# 3812 - Addendum 1

To	Kristen Haskell	Date	10/03/25
For	Long Creek Youth Development Center Ceiling Replacement	Project No.	BGS# 3812 SMRT# 25014

This addendum forms a part of the bidding and contract documents.

AE102

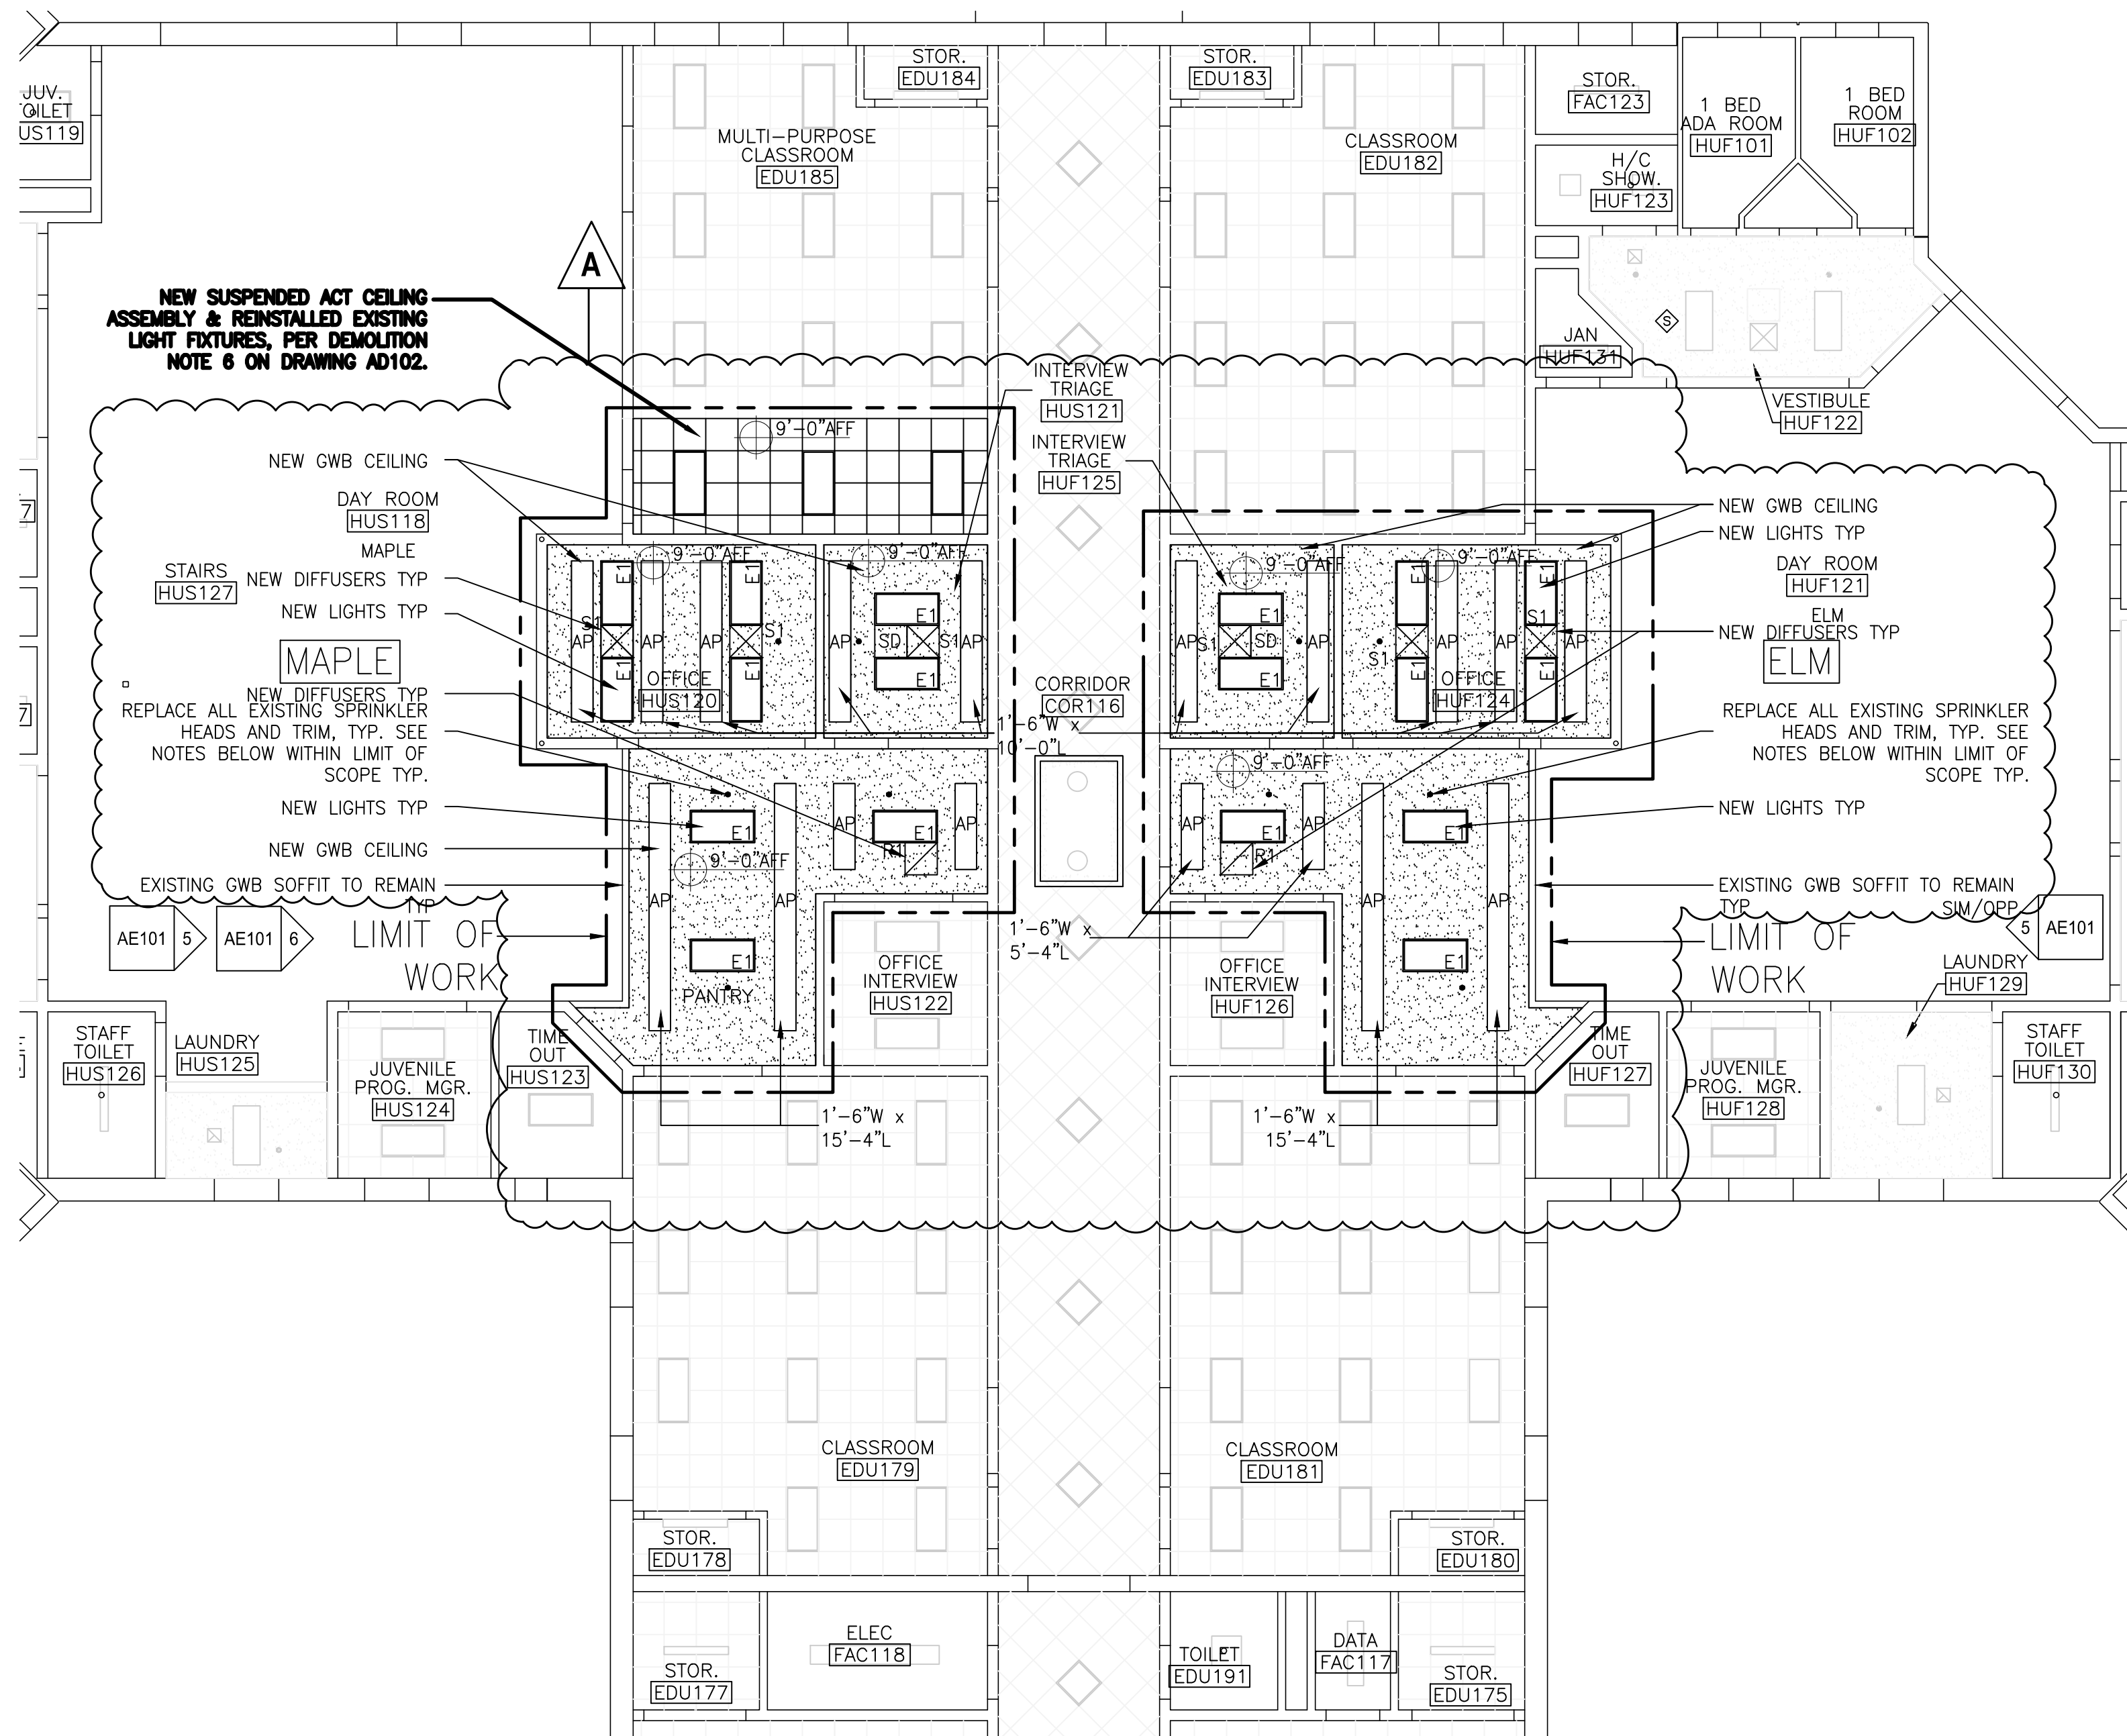
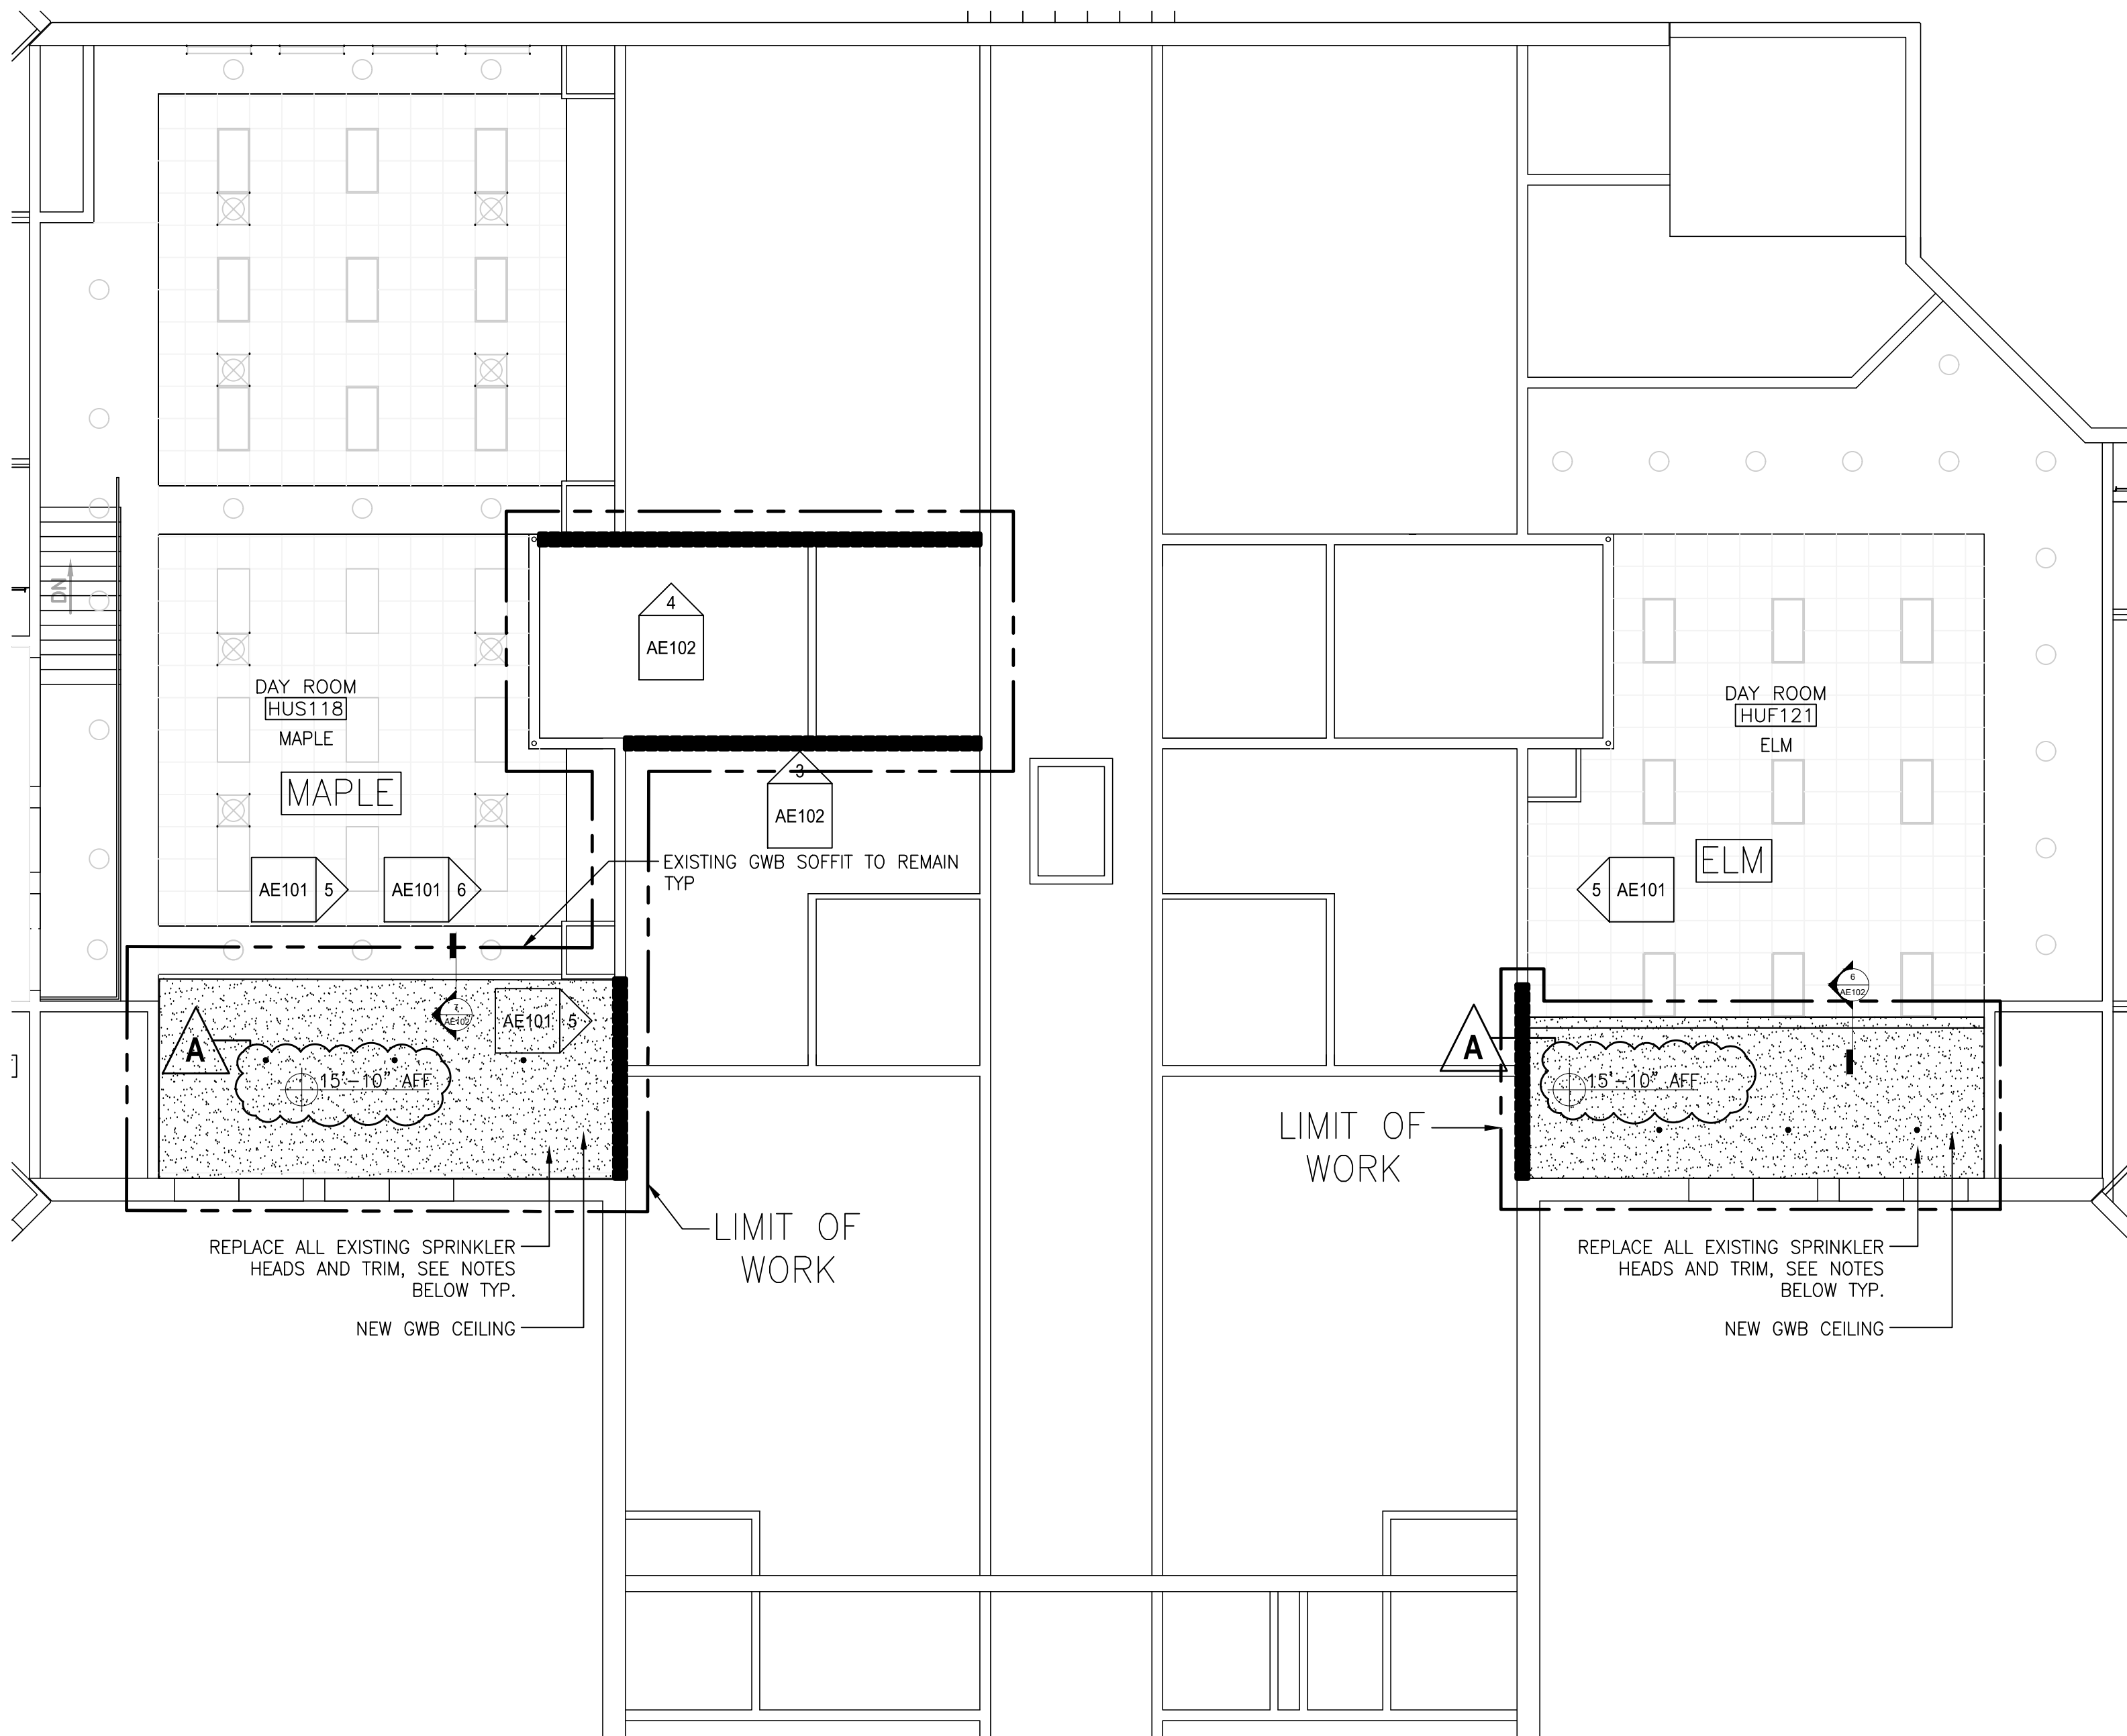
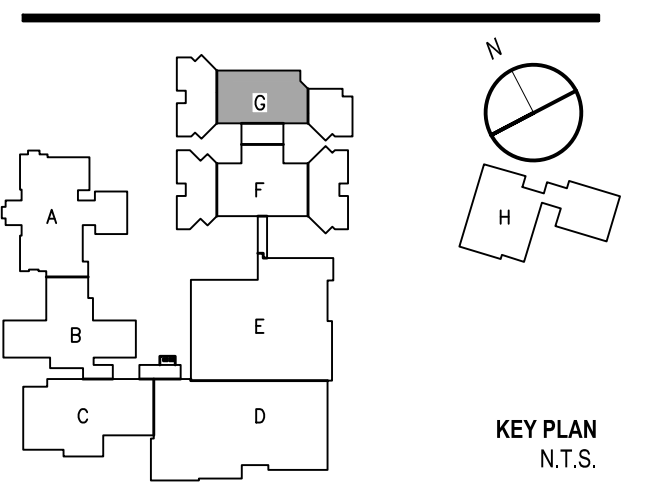
BIDDER QUESTIONS	
Q1.	Is the impact face is needed. There typically isn't a need for this type of face on the ceiling. RESPONSE: <b>Yes, the impact face is necessary.</b>
Q2.	AD102 existing pictures didn't come through on the plans? RESPONSE: <b>Refer to the attached revised drawing AD102 for photos.</b>
Q3.	Access panels are noted and mentioned to show minimum on plans? We don't see any shown. Is there a quantity we should carry with it being unknown? RESPONSE: <b>Provide (4) four security access panels within each housing unit, in addition to those called for on the reflected ceiling plans. Refer to added architectural note 10 on the attached revised drawing AE101 &amp; AE102.</b>

Q17.	For larger spans, please advise what the metal stud framing should be for the ceiling. Please provide a framing detail. RESPONSE: <b>Refer to specification section 092216 and the attached revised drawings AE101 &amp; AE102 for framing requirements.</b>
Q18.	Please advise what the metal stud framing for the new ceilings will be attached to and how it should be attached. Please provide a detail. RESPONSE: <b>Refer to specification section 092216 and the attached revised drawings AE101 &amp; AE102 for framing requirements.</b>
Q19.	What should be the finish height of the ceilings? RESPONSE: <b>Refer to the attached revised drawings AE101 &amp; AE102 for ceiling heights.</b>
Q20.	Please advise the height to the roof deck above the ceiling. RESPONSE: <b>Refer to architectural note 14 on the attached revised drawings AE101 and AE102 for bottom of steel roof deck height.</b>
Q21.	Are the walls in each room to be painted? If so, what paint and color? RESPONSE:

<b>No. Refer to the attached revised drawings AE101 &amp; AE102, and the attached revised specification section 099123 for paint scope clarifications.</b>
Q22.	Please confirm flooring is now included in this SOW. RESPONSE: <b>Flooring is not included in the scope of work. Any existing flooring damaged by construction activities would need to be replaced with new flooring.</b>
Q23.	Please advise what gauge metal studs should be installed. RESPONSE: <b>Refer to specification section 091116, 2.2, 1., a.</b>
Q24.	Please confirm no insulation is to be installed above the GWB ceilings. RESPONSE: <b>There's no insulation at the ceilings. Refer the drawings for required insulation locations.</b>
Q25.	Please advise who the existing fire alarm contractor is. RESPONSE: <b>Johnson Controls</b>
Q26.	Who services the existing fire suppression system? RESPONSE: <b>Johnson Controls</b>
Q27.	Can the superintendent be the SSHO & QCM? RESPONSE: <b>Yes.</b>
